Product Change Notification / NTDO-17SDDT634

CCB 4529 Final Notice: Qualification of MTAI as an additional assembly site for selected AT86RF215, ATmega644/1284/2564RFR2 and ATSAM4Lx8xx device families available in 48L VQFN (7x7x0.9mm) package.

CCB 4529
Pre and Post Change Summary
PCN#: NTDO-17SDDT634

Lead frame Comparison

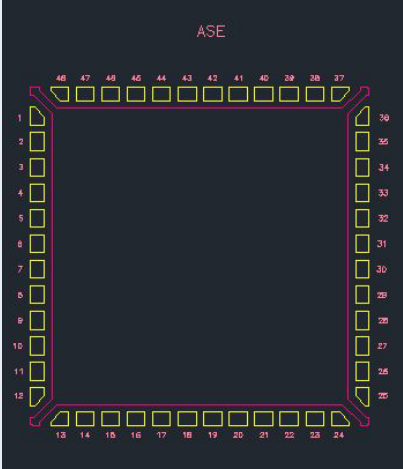
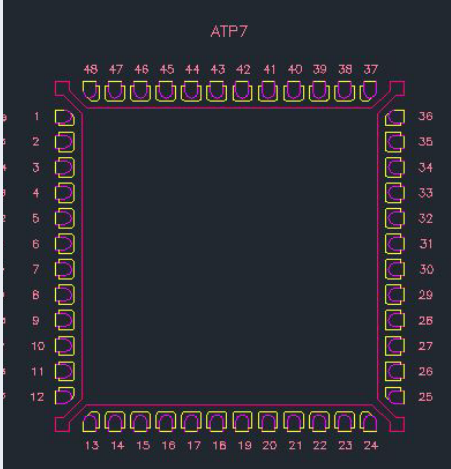
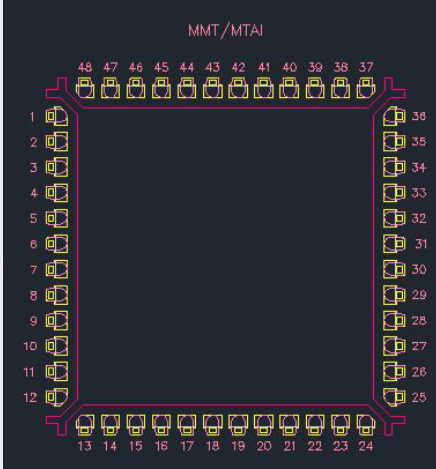
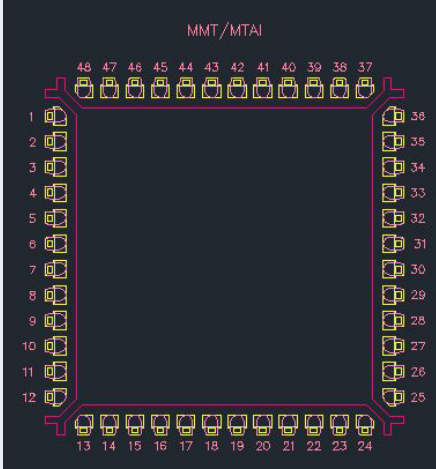
Pre Change		Post Change																									
ASE	ATP7	MMT	MTAI																								
 <p>Diagram of ASE lead frame showing a square frame with 48 pins (1-12 on each side) and Ag Ring plating on the DAP surface.</p>	 <p>Diagram of ATP7 lead frame showing a square frame with 48 pins (1-12 on each side) and Bare Cu on the DAP surface.</p>	 <p>Diagram of MMT/MTAI lead frame showing a square frame with 48 pins (1-12 on each side) and Bare Cu on the DAP surface. It features lead lock holes around the perimeter.</p>	 <p>Diagram of MMT/MTAI lead frame showing a square frame with 48 pins (1-12 on each side) and Bare Cu on the DAP surface. It features lead lock holes around the perimeter.</p>																								
<table border="0"> <tr> <td>Lead frame material</td> <td>C194</td> </tr> <tr> <td>Lead frame DAP surface prep</td> <td>Ag Ring plating</td> </tr> <tr> <td>Lead frame lead-lock</td> <td>No</td> </tr> </table>	Lead frame material	C194	Lead frame DAP surface prep	Ag Ring plating	Lead frame lead-lock	No	<table border="0"> <tr> <td>Lead frame material</td> <td>C194</td> </tr> <tr> <td>Lead frame DAP surface prep</td> <td>Bare Cu</td> </tr> <tr> <td>Lead frame lead-lock</td> <td>No</td> </tr> </table>	Lead frame material	C194	Lead frame DAP surface prep	Bare Cu	Lead frame lead-lock	No	<table border="0"> <tr> <td>Lead frame material</td> <td>C194</td> </tr> <tr> <td>Lead frame DAP surface prep</td> <td>Bare Cu</td> </tr> <tr> <td>Lead frame lead-lock</td> <td>Yes</td> </tr> </table>	Lead frame material	C194	Lead frame DAP surface prep	Bare Cu	Lead frame lead-lock	Yes	<table border="0"> <tr> <td>Lead frame material</td> <td>C194</td> </tr> <tr> <td>Lead frame DAP surface prep</td> <td>Bare Cu</td> </tr> <tr> <td>Lead frame lead-lock</td> <td>Yes</td> </tr> </table>	Lead frame material	C194	Lead frame DAP surface prep	Bare Cu	Lead frame lead-lock	Yes

Lead frame material	C194																										
Lead frame DAP surface prep	Ag Ring plating																										
Lead frame lead-lock	No																										
Lead frame material	C194																										
Lead frame DAP surface prep	Bare Cu																										
Lead frame lead-lock	No																										
Lead frame material	C194																										
Lead frame DAP surface prep	Bare Cu																										
Lead frame lead-lock	Yes																										
Lead frame material	C194																										
Lead frame DAP surface prep	Bare Cu																										
Lead frame lead-lock	Yes

Note: The lead lock hole fills with mold compound during the assembly process and provides improved protection against moisture penetration around the interface edges between pins and mold compound.
